**re:     Geotechnical Review of Grading Plans**  
**Proposed Commercial Development**  
1015 & 1045 Dairy Drive – Ottawa, Ontario  
**to:     TSL-DAIRY Inc. – Mr. Alexander Shafran – ashafran@efforttrust.ca**  
**date:   July 2, 2025**  
**file:   PG6498-MEMO.03**

## **Grading Plan Review**

- ☐ Project No. 142817 – Grading Plan – Dairy Dr Grading, dated June 19, 2025.

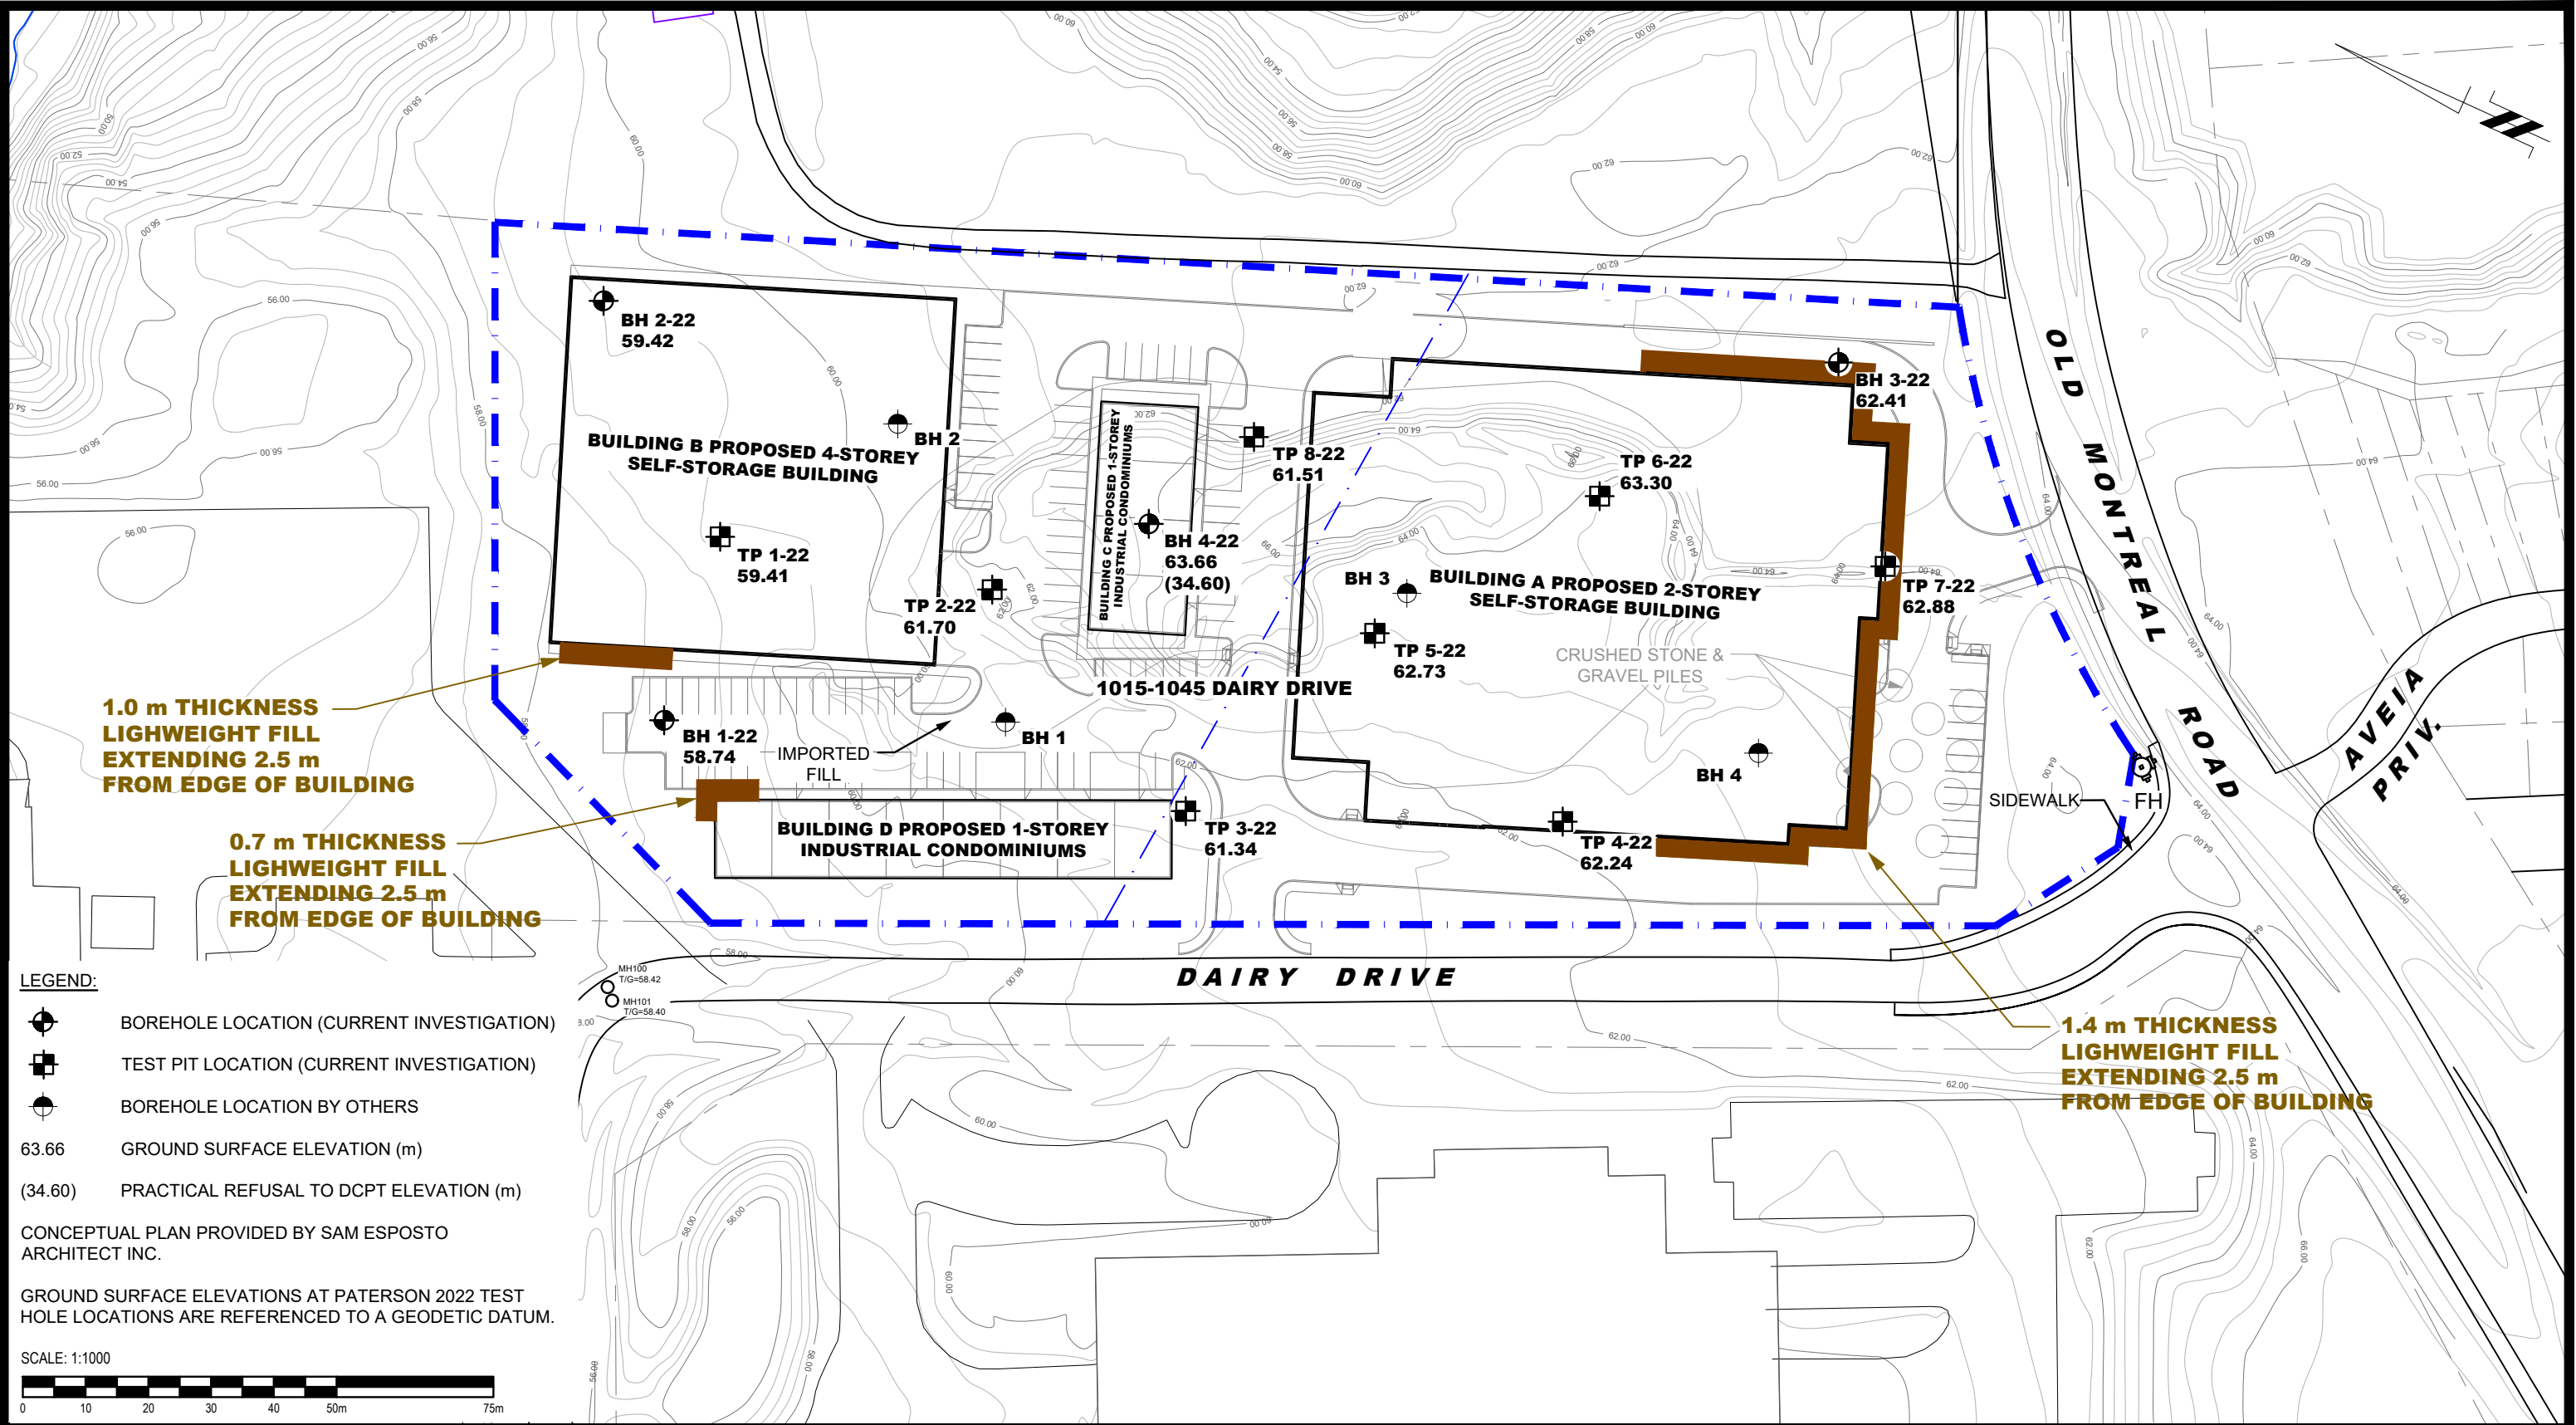
In reviewing the Grading Plans, the proposed grading for the subject site is generally within the permissible grade raise recommendations provided in the Geotechnical Investigation Report, referenced above. However, where localized grade raise exceedances have occurred, lightweight fill, such as expanded polystyrene (EPS) geofoam blocks, is recommended for specific areas adjacent to the subject commercial buildings.

The attached Drawing PG6498-7 depicts the locations and the thickness of the lightweight fill (LWF) required based on our grading plan review, and the attached Figure 1 provides a general detail for LWF placement. The EPS blocks should be placed on a level, well-prepared subgrade, with a geotextile separation layer to prevent soil intrusion and to promote drainage. The EPS blocks should be installed in a staggered, interlocking pattern and should be protected with a granular cover layer. The LWF placement should be conducted under the supervision of a geotechnical engineer.
